MIL-STD-202F

TEST METHODS FOR ELECTRONIC AND ELECTRICAL COMPONENT PARTS

MIL-STD-202F
NOTICE 7
28 March 1985MILITARY STANDARD
TEST METHODS FOR ELECTRONIC AND
ELECTRICAL COMPONENT PARTS

1. THE FOLLOWING PAGES HAVE BEEN REVISED AND SUPERSEDE THE PAGES LISTED:

FIGURE 101-2. Location of salt solution filler.

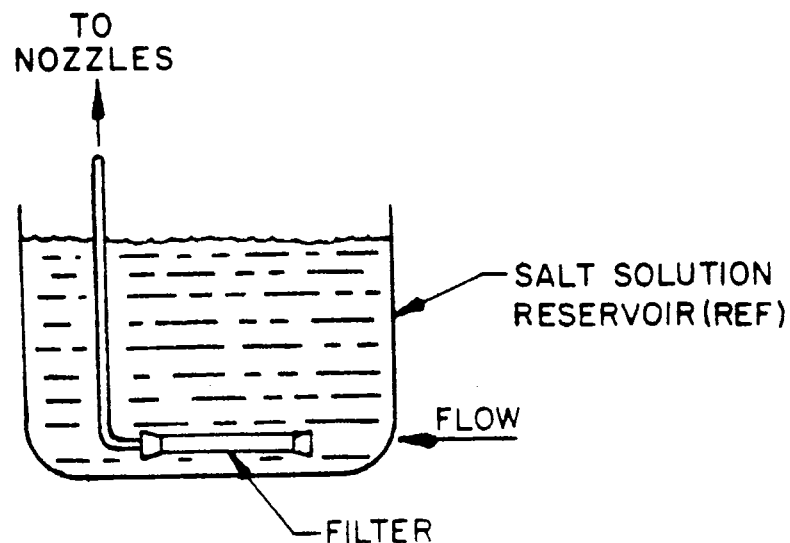
METHOD 101D, PAGE 3, FIGURE 101-2, TITLE: Delete "filler" and substitute "filter".
